SUBJECT: File 6248.00 – Rural Municipality of Stanley – Regional Wastewater Collection System - Information for Public Registry

RE: Rural Municipality (RM) of Stanley – Environment Act Proposal (EAP) Responses to Environmental Approvals Branch Additional Information Request Items – File 6248.00

1 | CASING PIPE DETAIL
Scale 1:100

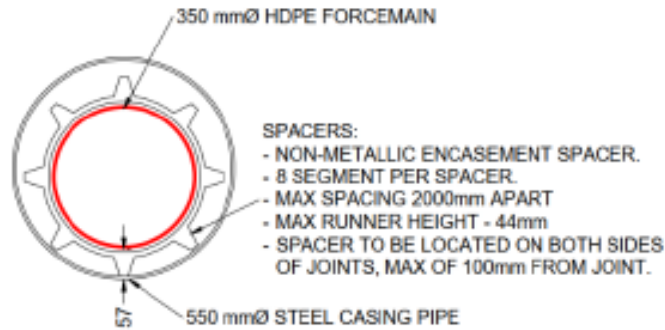
2. *Please confirm whether double casing or encasement will be applied at pipeline crossings. If not, kindly provide a comprehensive engineering justification for the proposed alternative.*

Steel casing pipes will be applied at all piping crossings. The proposed casing pipes specification and grade: ASTM 453 Grade B Welded Steel; minimum yield strength: 242 MPA; type of joint: welded. Please see the following image for the proposed casing pipe cross section detail.
